Phase I
Inspection
Report for
June 1979 **MATILIJA
DAM**

NATIONAL PROGRAM FOR INSPECTION OF DAMS
PHASE I INSPECTION REPORT
FOR
MATILIJA DAM
VENTURA COUNTY, CALIFORNIA

BRIEF ASSESSMENT: This report has been reviewed by this office and I concur with your assessment that Matilija Dam appears to be safe. I also agree with recommendations for monitoring behavior of the dam.

Photo No. 5.3
Left side of arch. Note cracking at
lift lines.

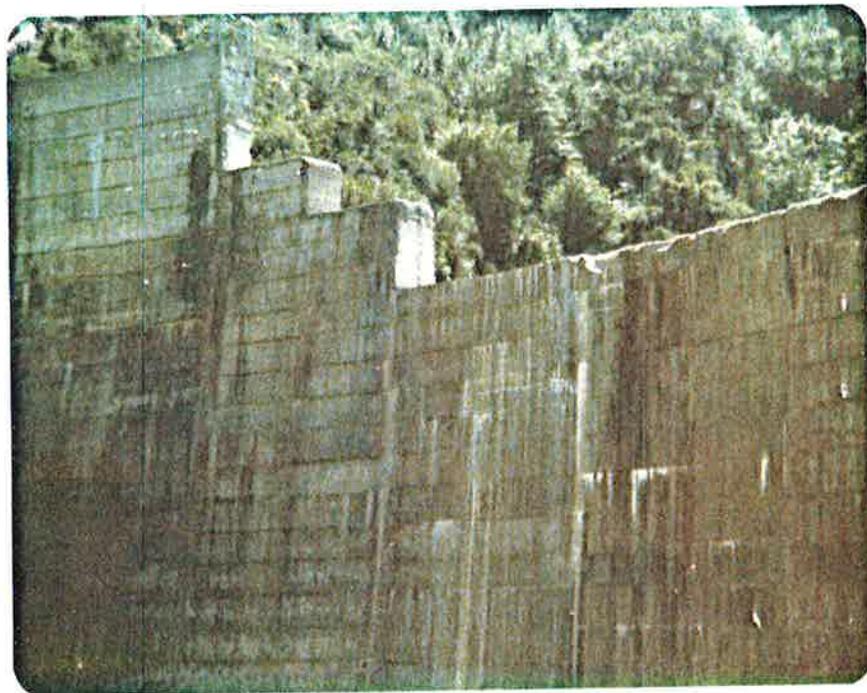
Photo No. 5.4
Center arch. Note crack pattern on
lifts and between lifts.

Photo No. 5.5
Downstream face above outlet. Note
cracking adjacent to notch and large
crack openings on lift joints.

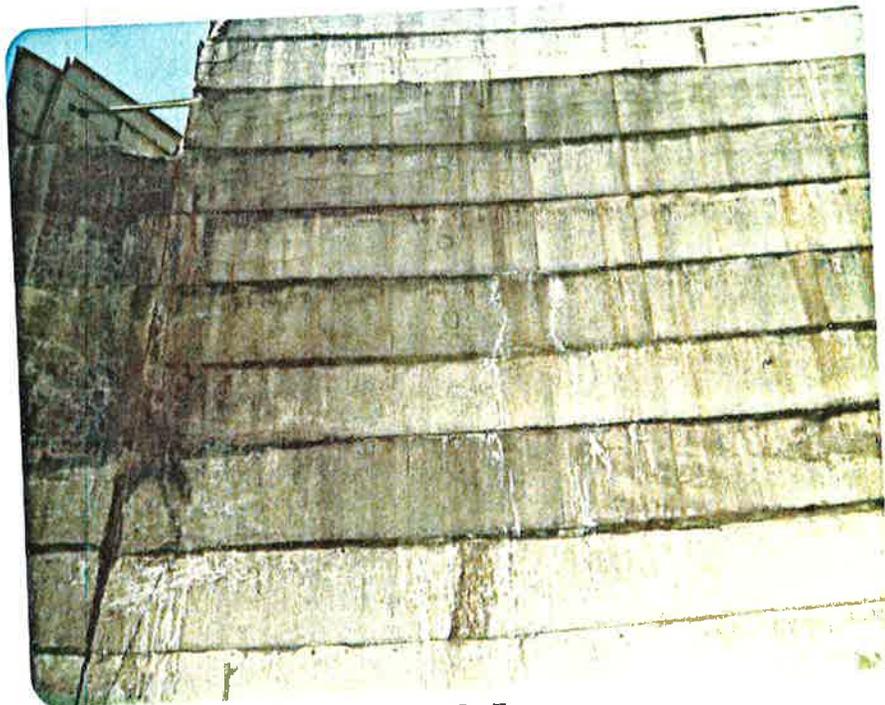
Photo No. 5.6
Downstream face above and left of
outlet. Note cracking.

Photo No. 5.8
Outlet intake riser. Note damaged area.

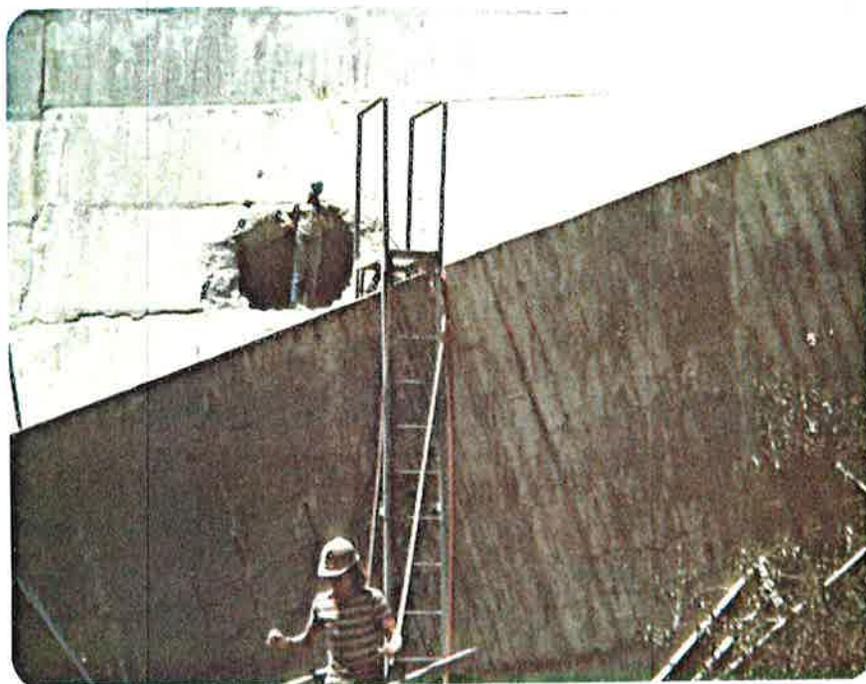
The temporary meter riser installed in 1970 was found to be damaged, apparently buckled inward during releases this past winter. Mr. Stephenson informed Mr. Sheydayi that the riser should be replaced this year. (Subsequently confirmed by letter July 12, 1978.)

3. To maintain outlet capacity the intake riser should be repaired. This has been requested of the owner. The owner has filed and received approval from the California Division of Safety of Dams for replacement of the intake riser; construction is scheduled for the fall of 1979.
